**Re: Committee of the Whole – March 6, 2018
New Community Area Block 27 Secondary Plan Study (File # 26.4.1)
Block 27 Landowner's Group Comments**

Commenting Matrix

Draft Block 27 Secondary Plan (File #26.4.1)

SCHEDULE B BLOCK 27 LAND USE PLAN

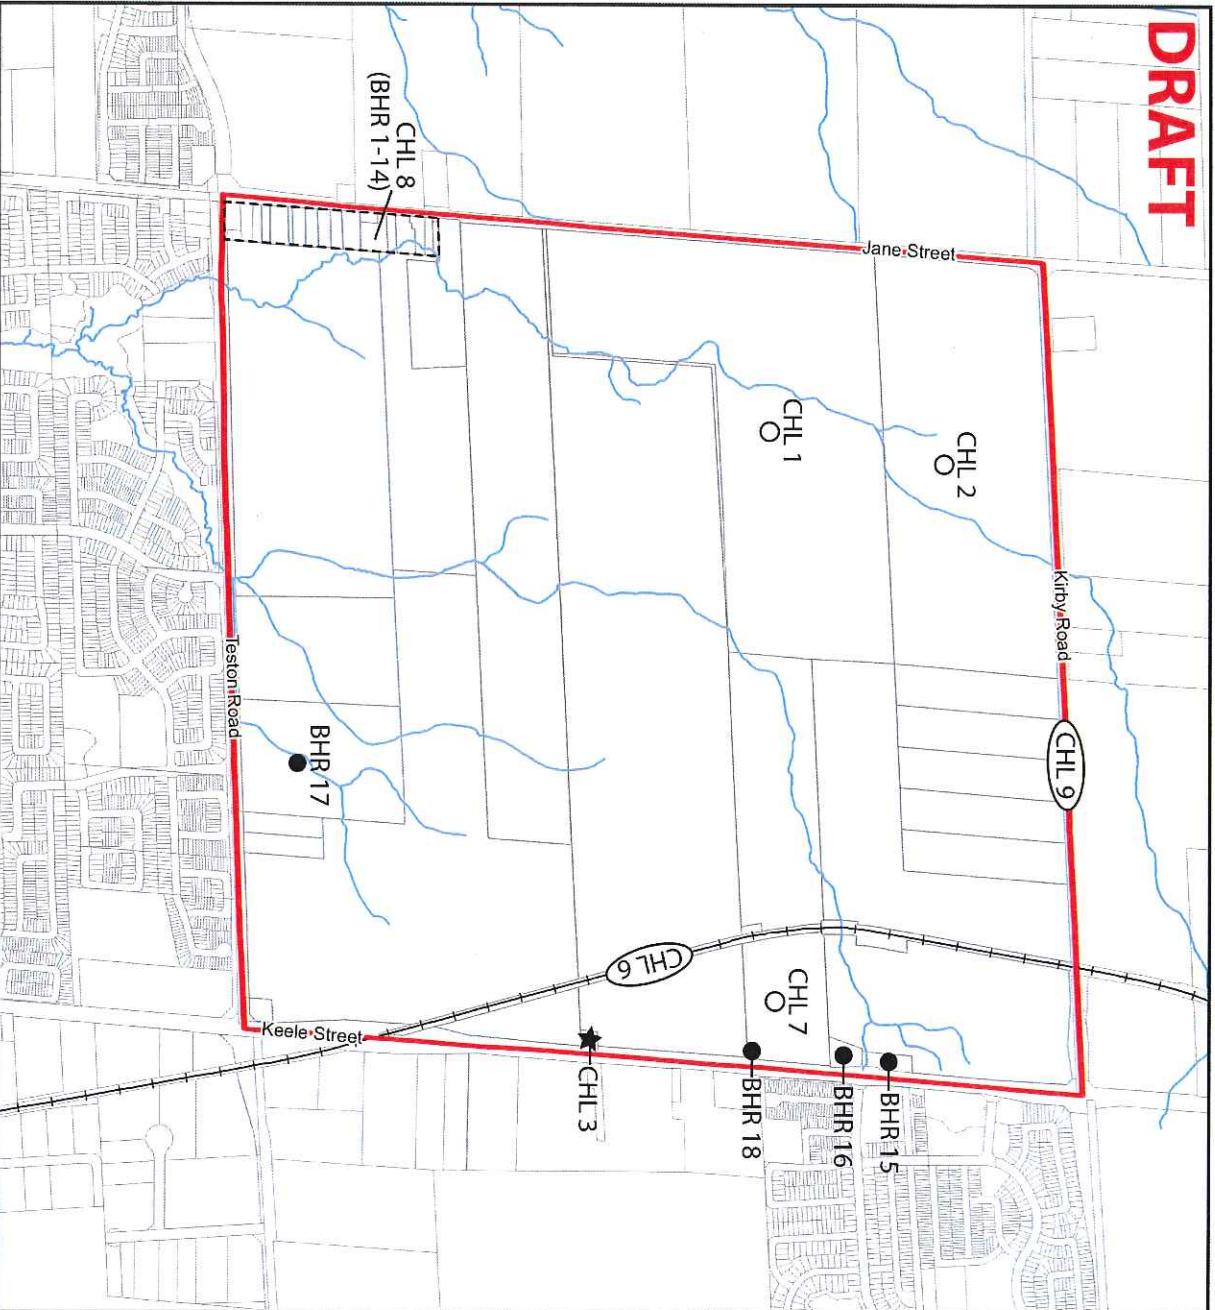
Shift Collector Road North to allow E/W collector and pipeline

Remove all Minor Collector Roads

Shift SWM Pond

Remove Wetland

Location and width of pipeline easement to be confirmed. Appears to be wider and not properly aligned.

Remove Wetland Add Mid-Rise Residential

Add Low-Rise Mixed-Use

Expand Natural Areas Special Study Area 1

Only those identified Potential SWM Facilities are to be identified on the plan

Remove Max. Height reference
